Probridhi Apparels Ltd

12 June, 2016

Client Summery Report

Stability against lateral loading

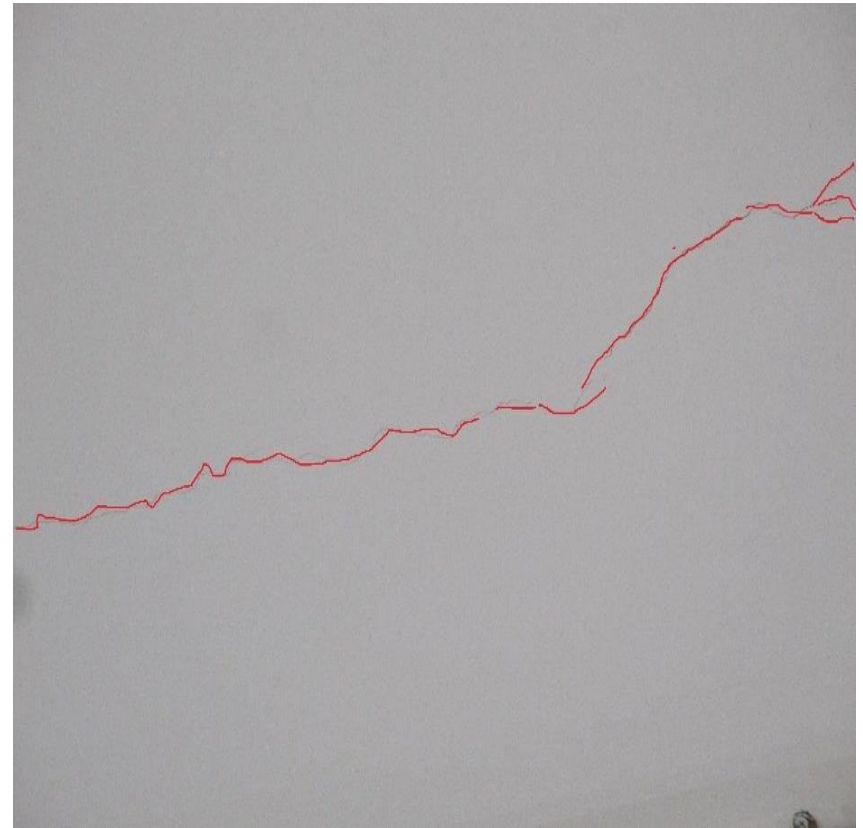
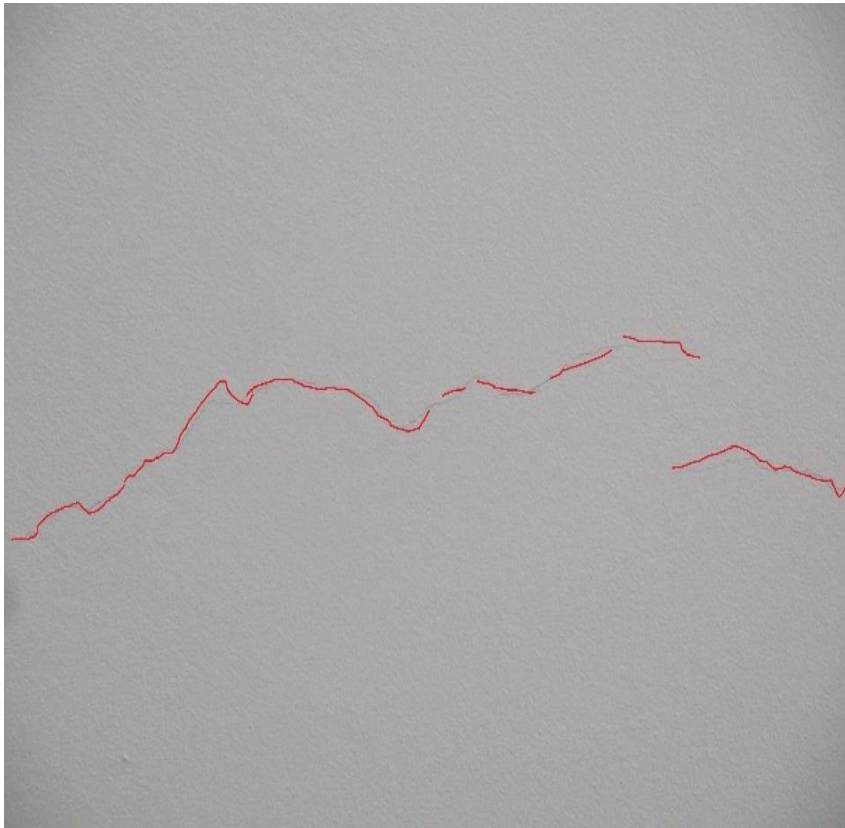
Main Building is narrow on plan. Lateral stability is primarily provided by moment frames. Lateral stability of the building should be checked to ensure it can withstand design lateral loadings.

- Building engineer to perform stability check for main building against lateral loading

- Implement strengthening measures in the building, if required

Cracks in 4th floor slab soffit

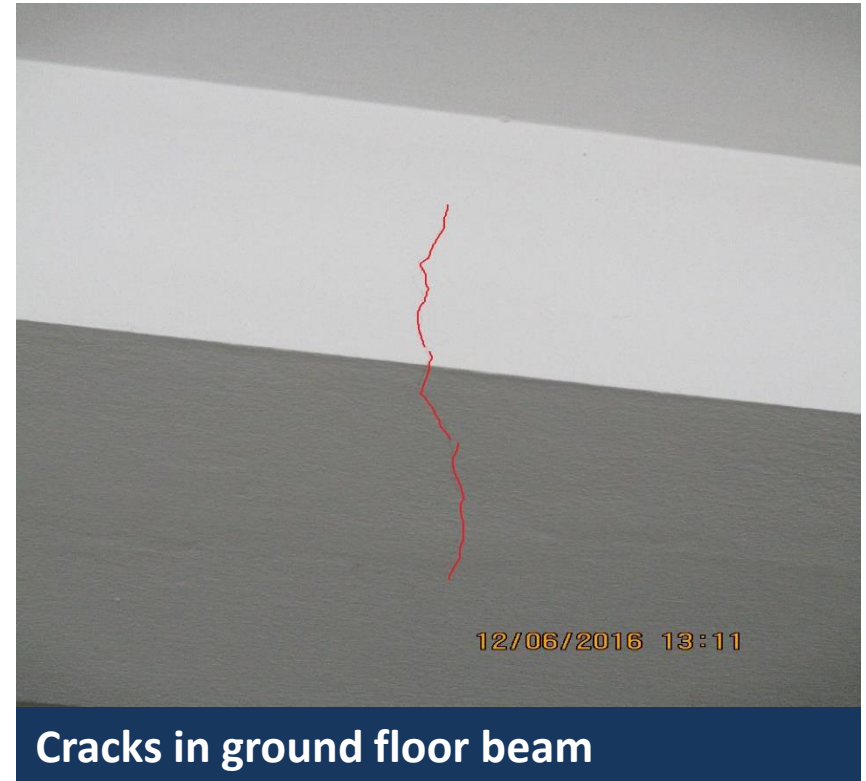
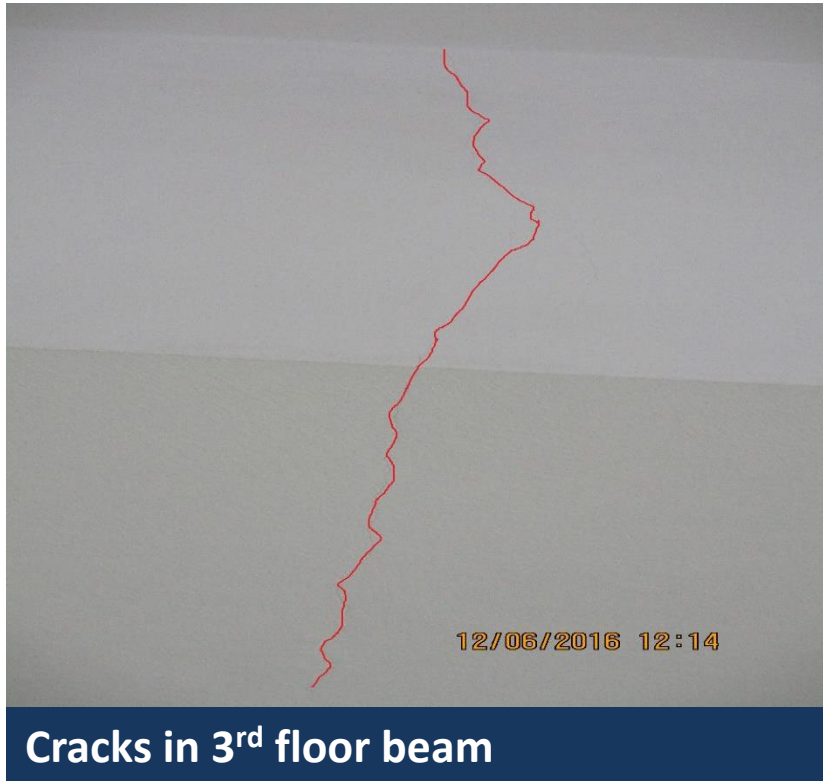
Cracks found in beam and slab soffits in part-A. The cause of cracking must be checked if the slab is adequate or not to bear loading from floor.

- Factory Engineer to survey and identify the cause of cracking

- Repair the cracks with suitable method, if required
- Produce and actively manage a loading plan for all floor plates within the factory giving consideration to floor capacity and column capacity.

Localized areas of High Loading

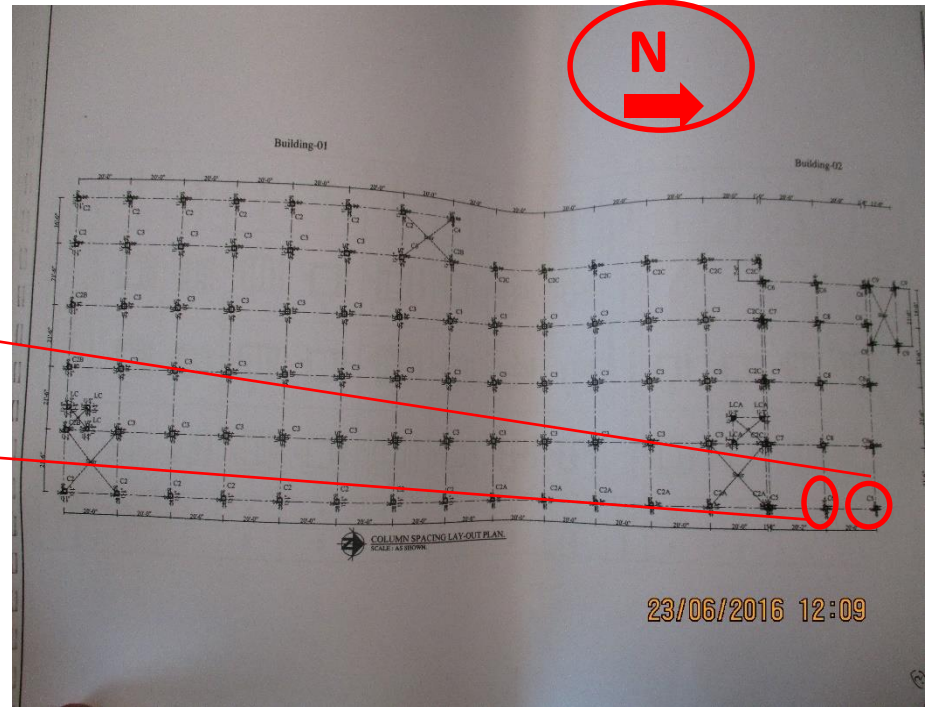
We observed loading was more than 2Kpa in Finished Goods area at 3rd floor and Yarn Store at 2nd floor. Factory provided us a copy of certificate which shows load is within allowable limit but this certificate doesn't show design load. Therefore factory engineer to produce load plan for all floors.

- Produce and actively manage a loading plan for all floor plates within the factory giving consideration to floor capacity and column capacity.

- Continue to implement load plan.
